**Southern
Water**

Our ref
PLAN-029273

Proposal: Partial demolition of existing structures. New dwelling (1.5 storey) with separate single storey double garage. Existing mobile home to be replaced with new, smaller mobile home - This application is a Departure from the Development Plan.

Site: BN/47/19/PL: - The Cottage Piggeries, Church Lane, Barnham, PO22 0DB.

ARUN DISTRICT COUNCIL BN47/19/PL

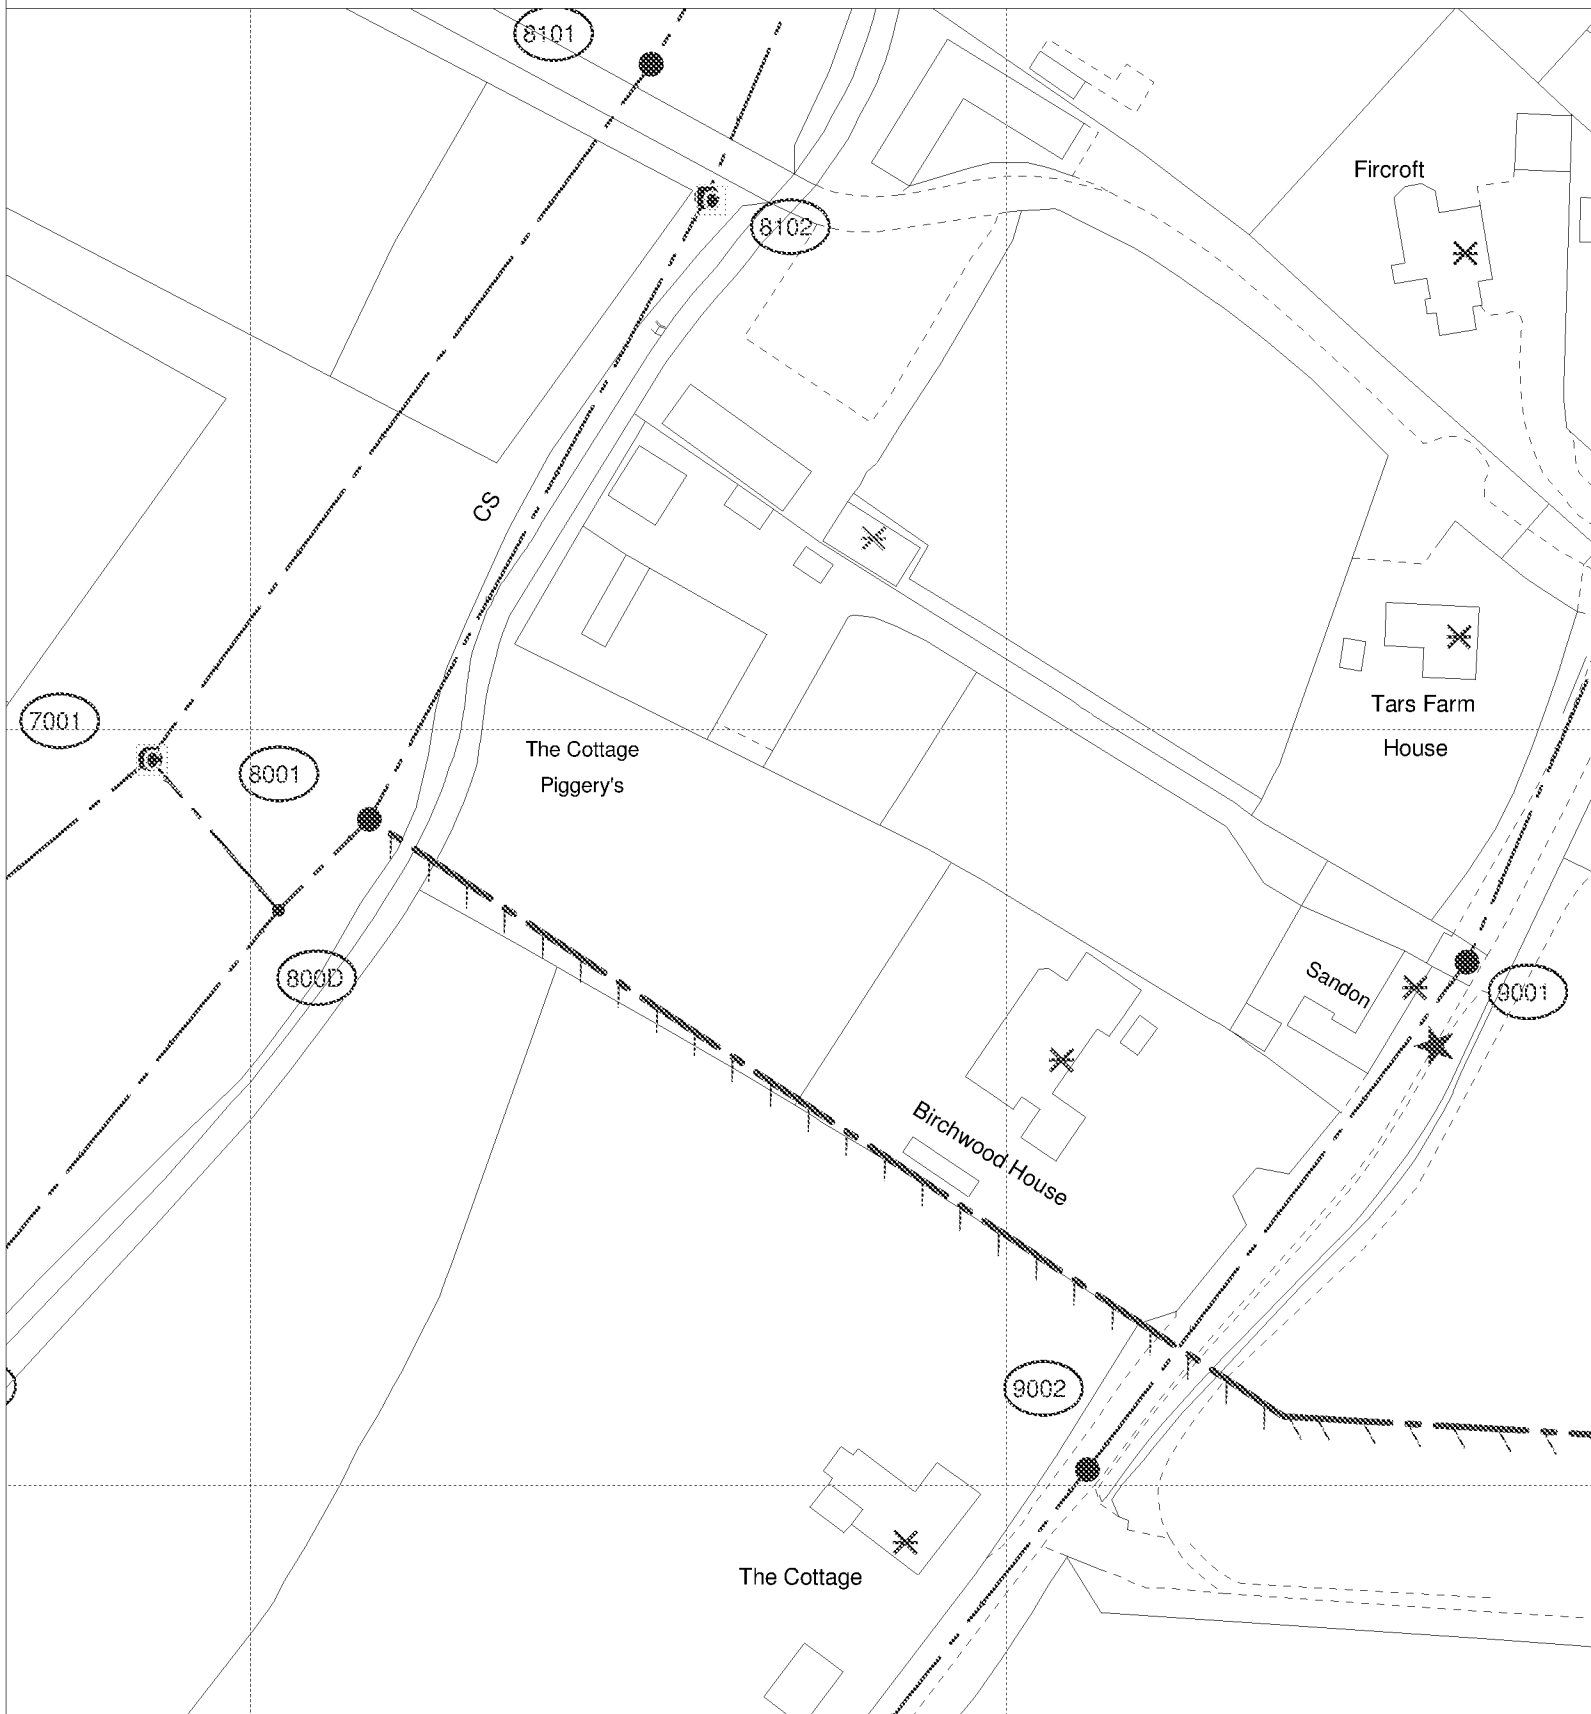
Please see attached an extract from Southern Water records showing the approximate position of our existing foul rising main within the site. The exact position of the public rising main must be determined on site by the applicant in consultation with Southern Water, before the layout of the proposed development is finalised.

- The foul rising main requires a clearance of 3 metres on either side of the rising main to protect it from construction works and to allow for future access for maintenance.
- No development or tree planting should be carried out within 3 metres of the external edge of the public rising main without consent from Southern Water.
- No new soakaways should be located within 5 metres of a public or adoptable gravity sewer, rising main or water main.
- All existing infrastructure should be protected during the course of construction works.
